SHOP DRAWING REVIEW

Job Number: 52211
Reviewed By: SMH
Date: 10/25/05

△	ADDED FIELD SPLICE	DRJ	8/5/05
△	INCREASE LENGTHS TO SATISFY REQUIREMENTS FOR LENGTH & MEAN TEMPERATURE OF 45°F.	JSA	9/17/04
NO.	REVISION	BY	DATE
<p>HIGH STEEL STRUCTURES, INC.</p> <p>1770 Hempstead Road Lancaster, PA 17605-0008 Phone 717/299-5211</p> <p>A Division of High Industries, Inc.</p>			
GIRDER G7N			
VT 78 OVER MISSISSOQUI BAY, BRIDGE NO. 2			
VT 78 STA.10+970.425 TO STA.12+059.775			
TOWNS OF ALBURG AND SWANTON			
COUNTIES OF GRAND ISLE AND FRANKLIN			
STATE OF VERMONT, AGENCY OF TRANSPORTATION			
STATE CONTRACT OR REF. NO. BRF-036-1(1)			
CONTRACTOR CIAMBRO CORPORATION			
IN CHARGE: GLIDDEN (IH) MADE BY: ERS CHK'D. BY: CS DATE: 8-23-04			
CONTRACT NUMBER: VT-04057-2 DRAWING NUMBER: 55 OF 112

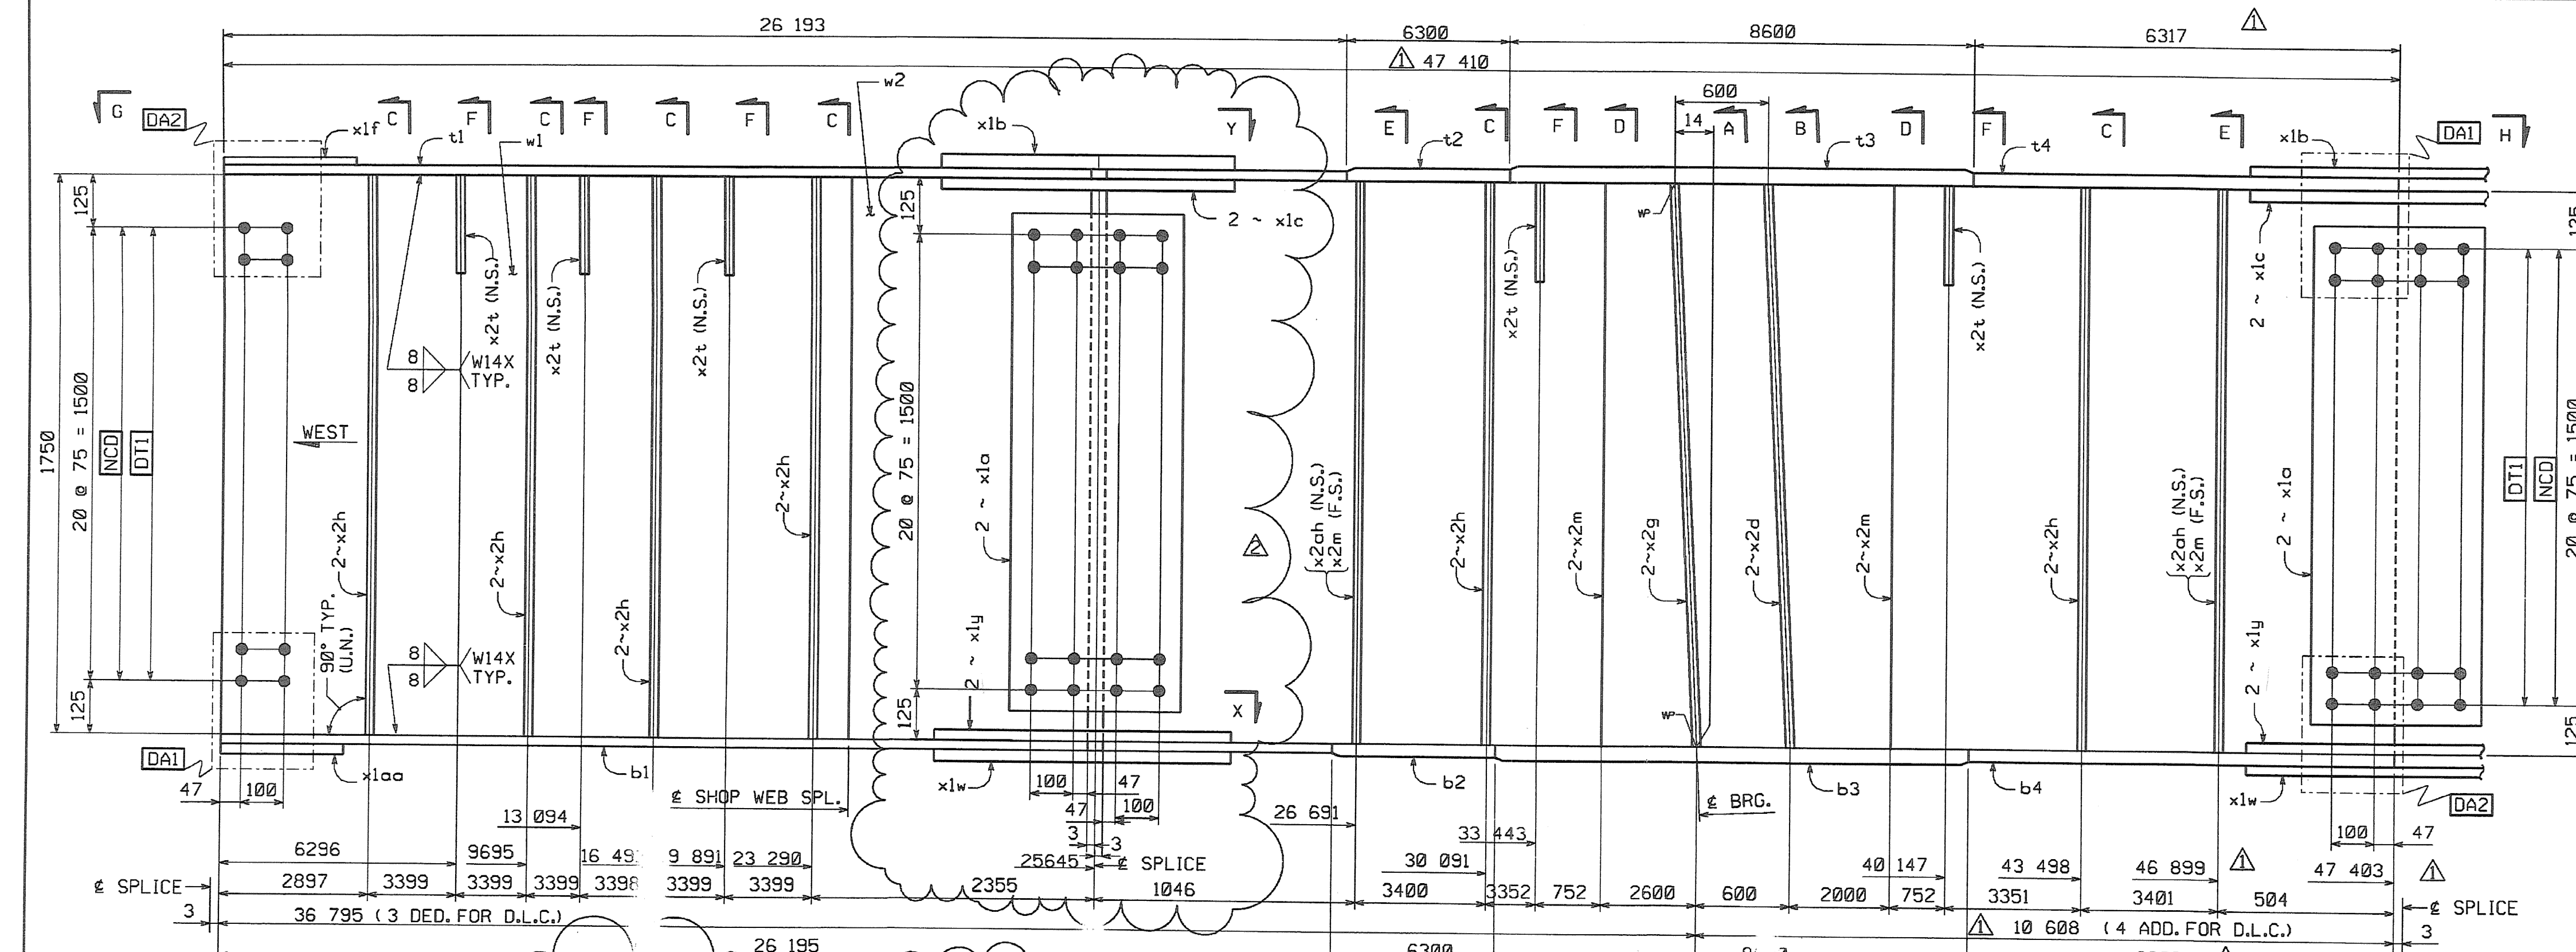
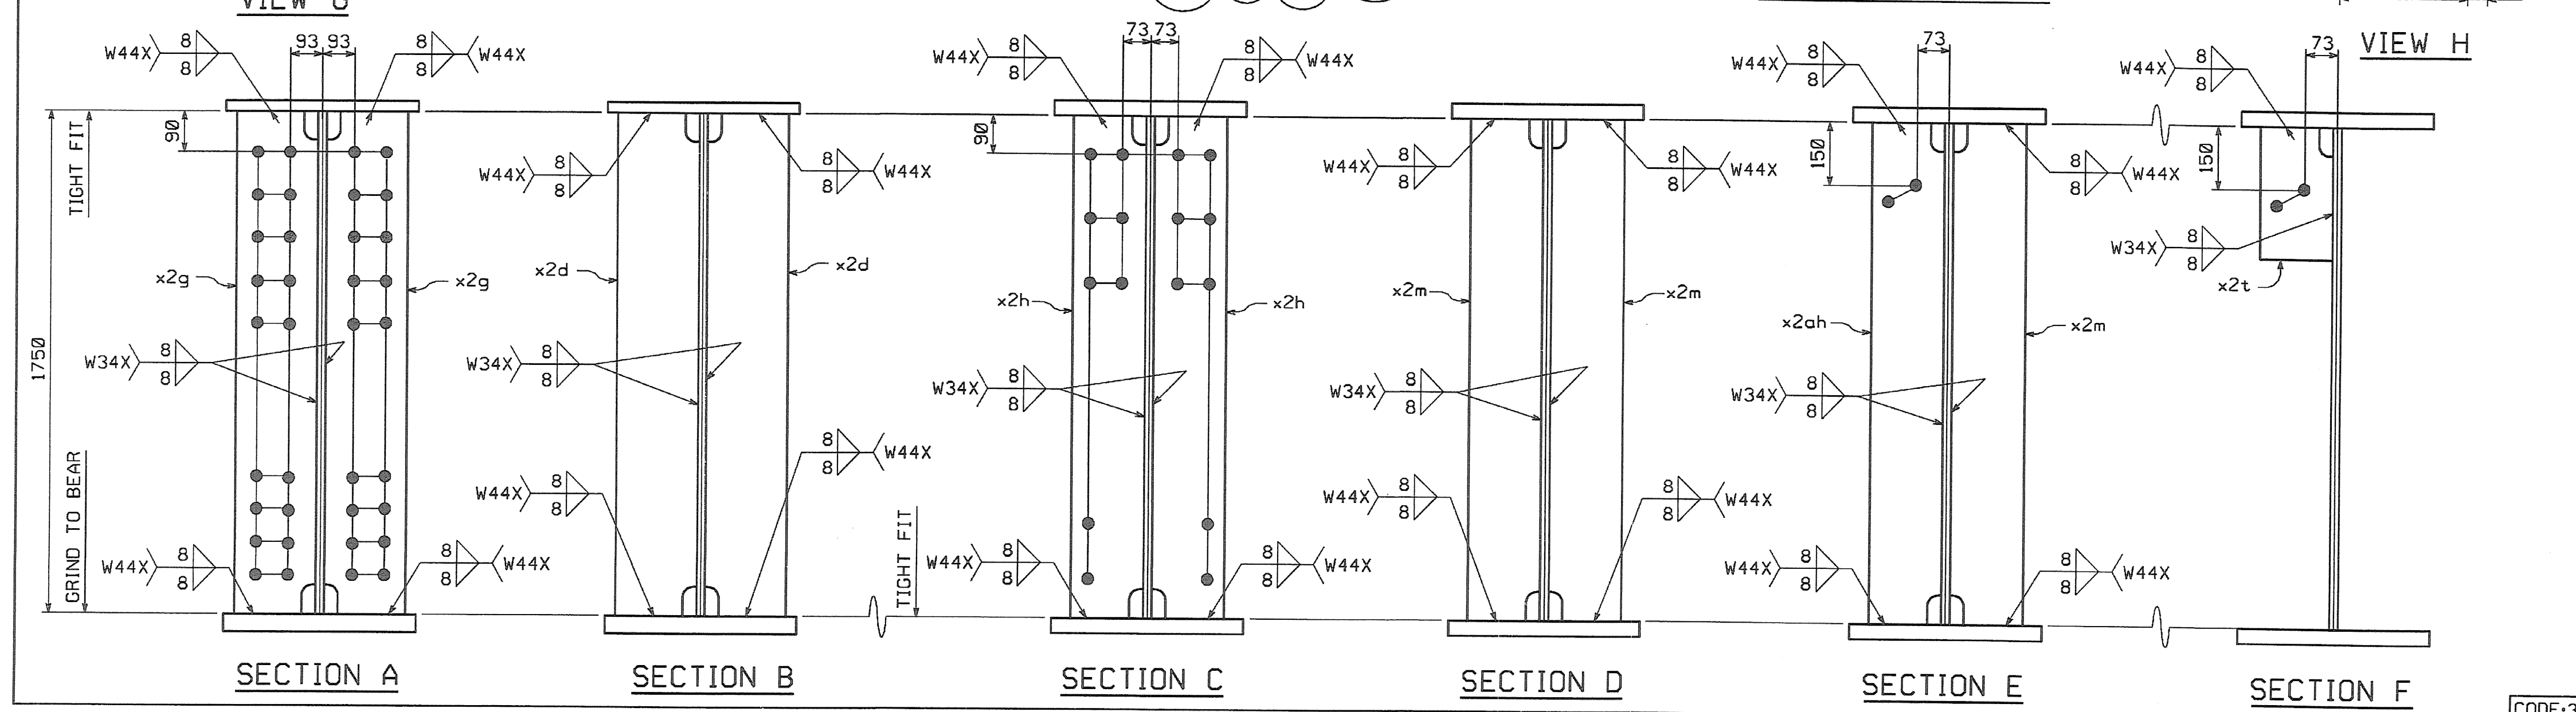
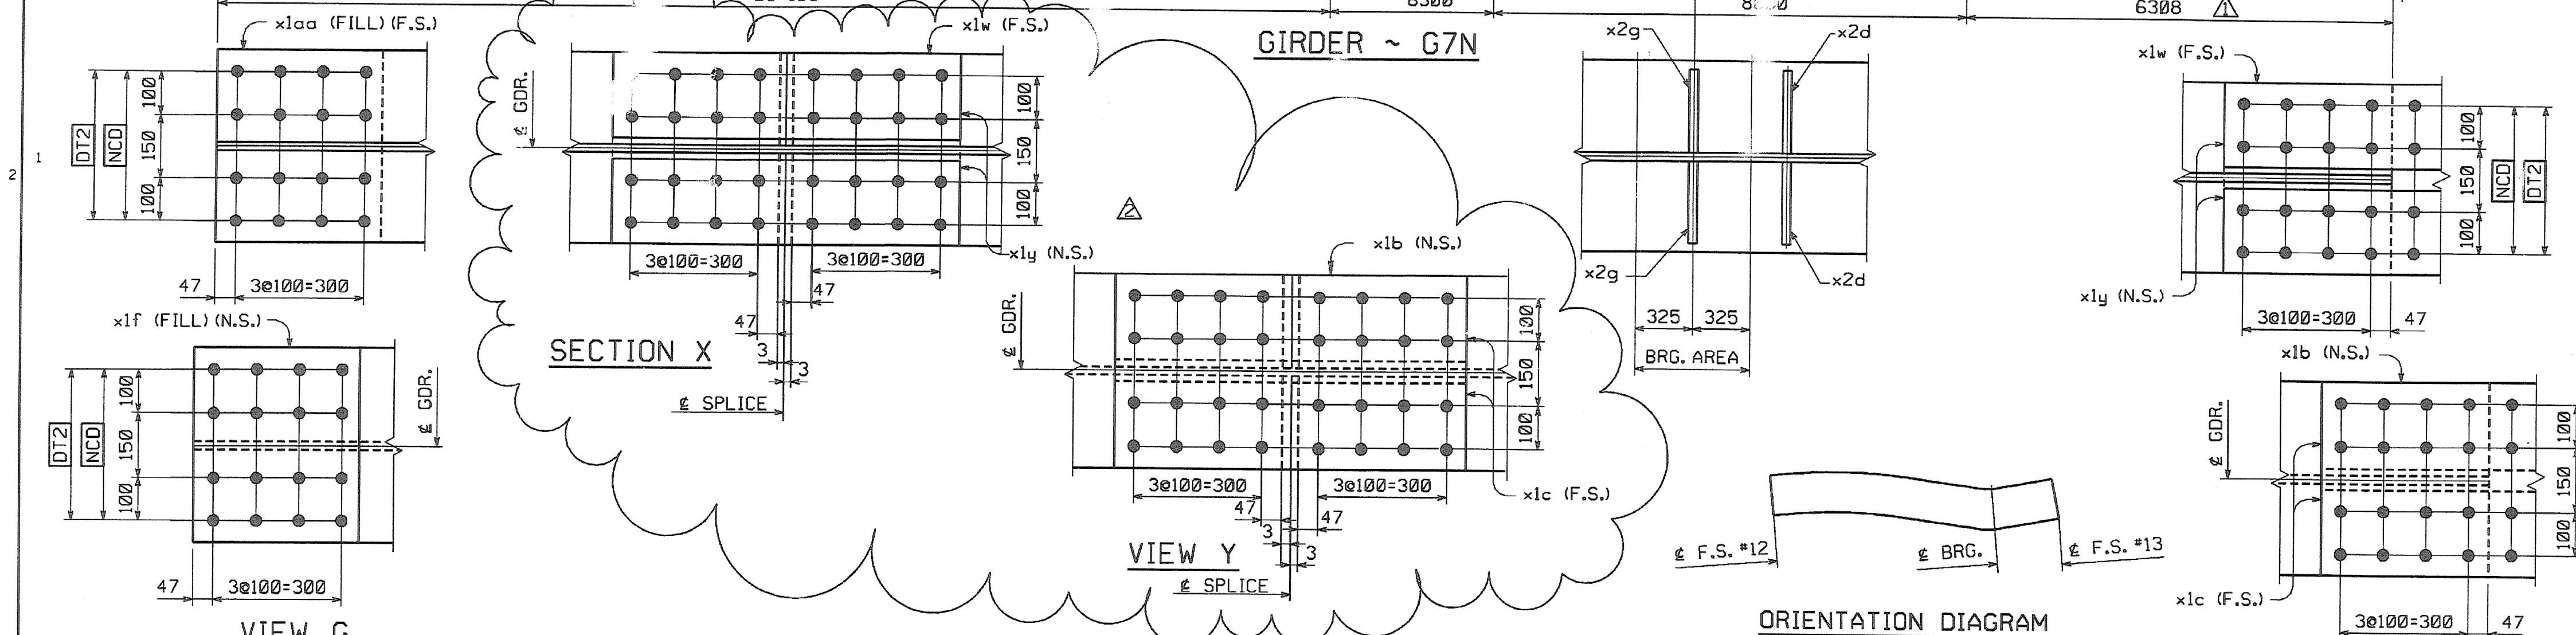
0.6mm Substituted For Field Splice
22 915.44 kg
JMR 8-3-06
